Accepted Value Engineering Options

FIREHOUSE APARTMENTS

ELEVATIONS
BUILDING 'A'

A-2.0

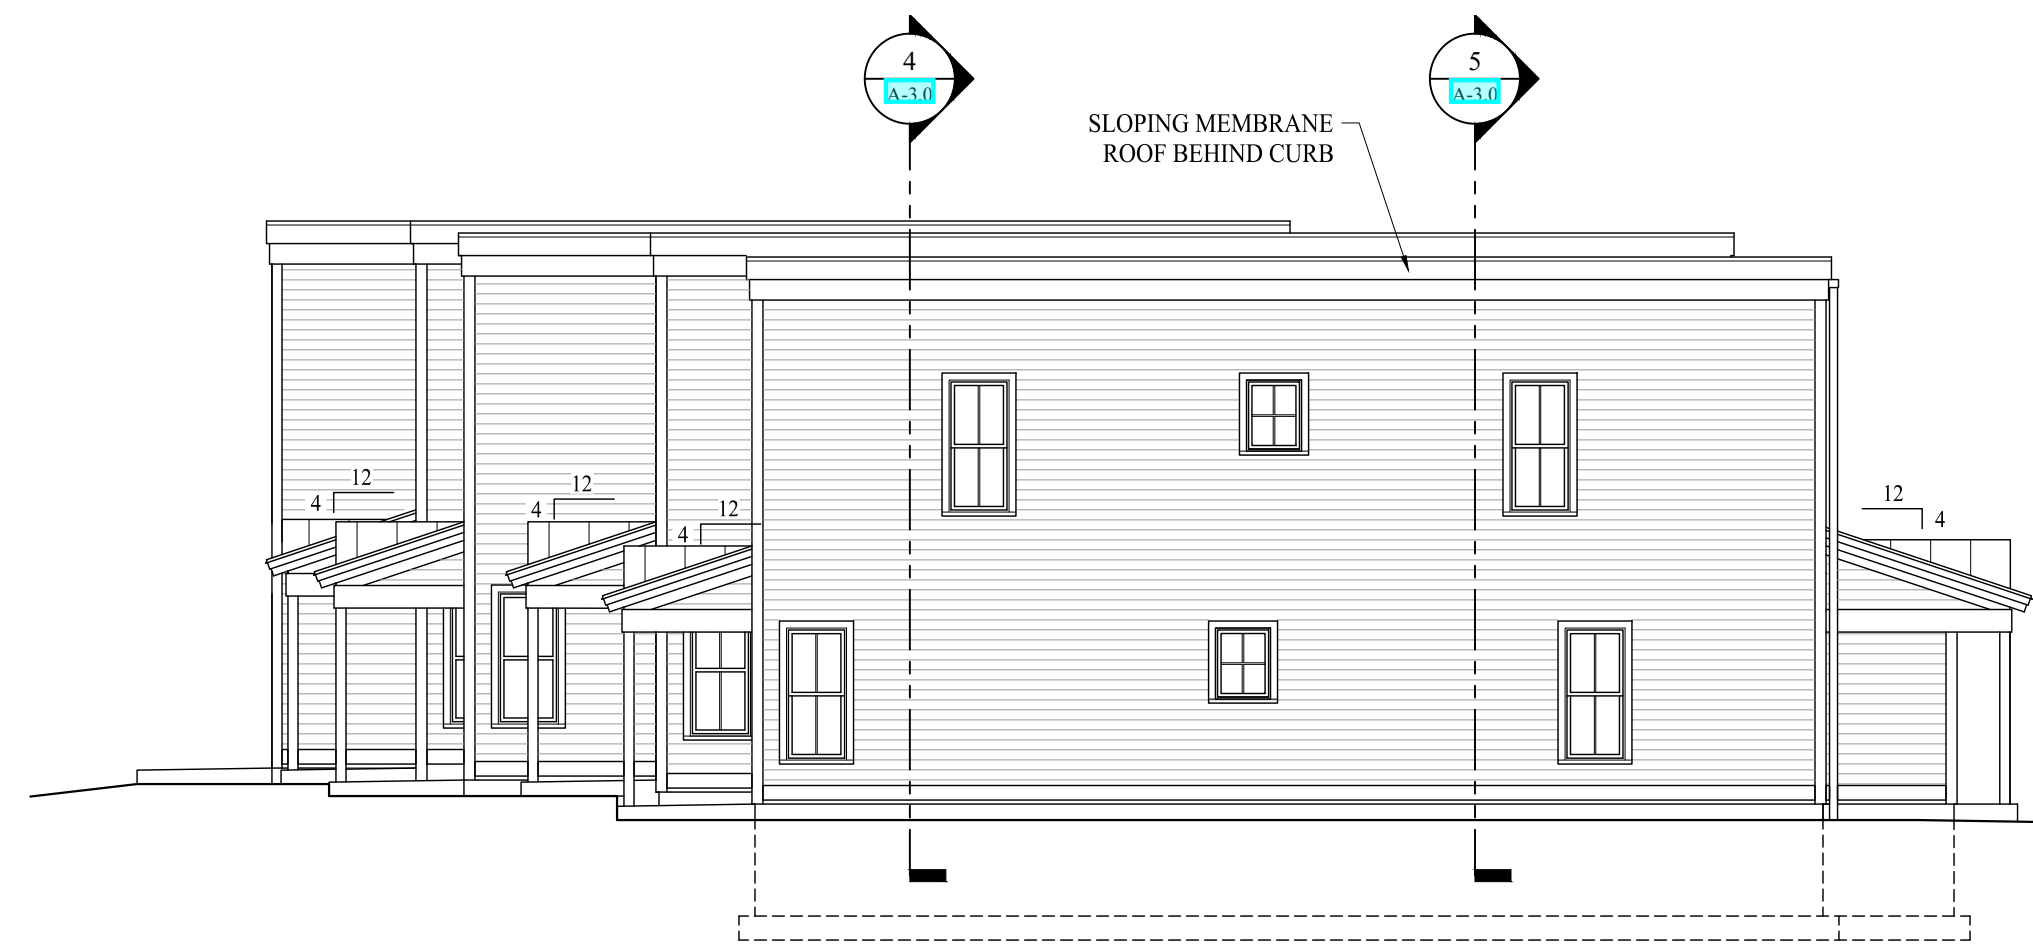
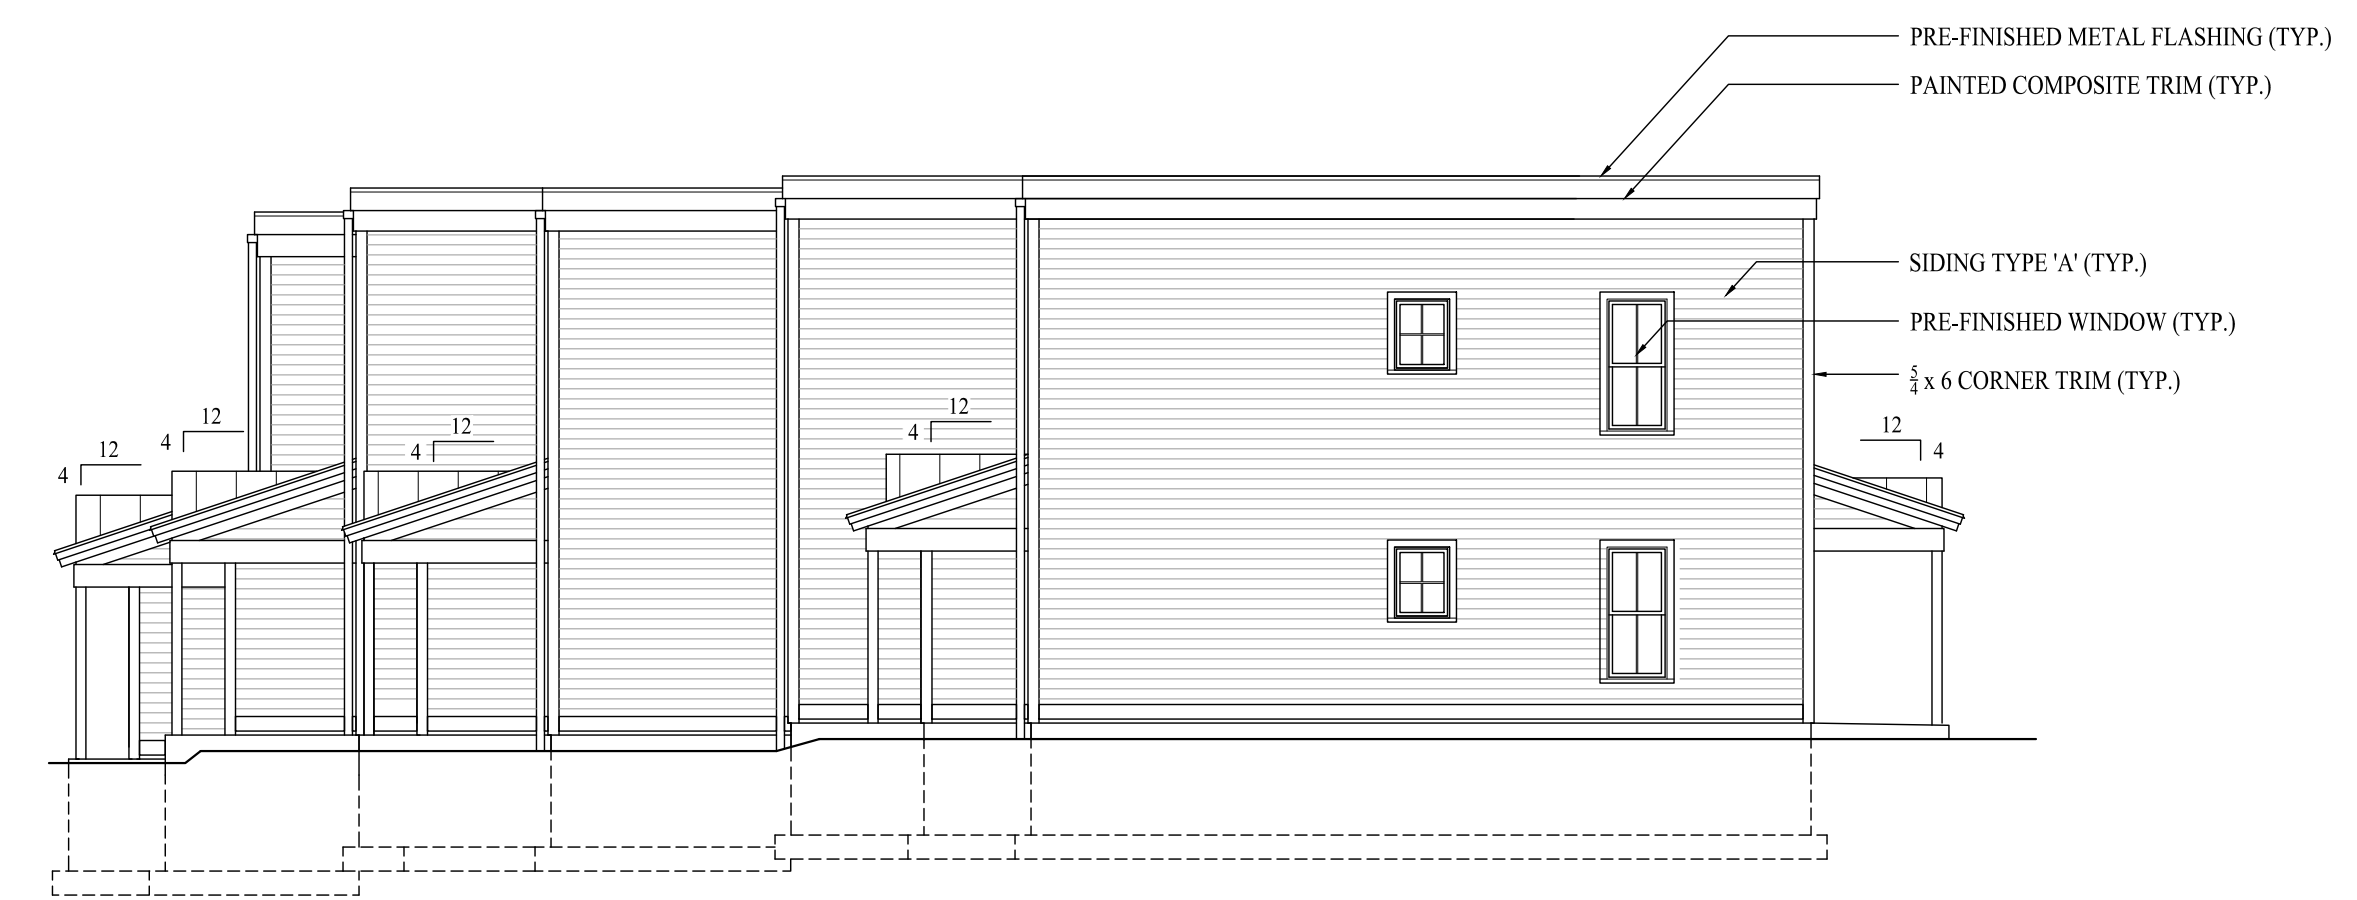
1. VE #1a - Consider Vinyl Siding ILO Fiber Cement. Exterior trim changes to Hardie Fiber Cement ILO Boral
2. VE #2e - Consider Paradigm windows (U value 0.27) ILO Marvin
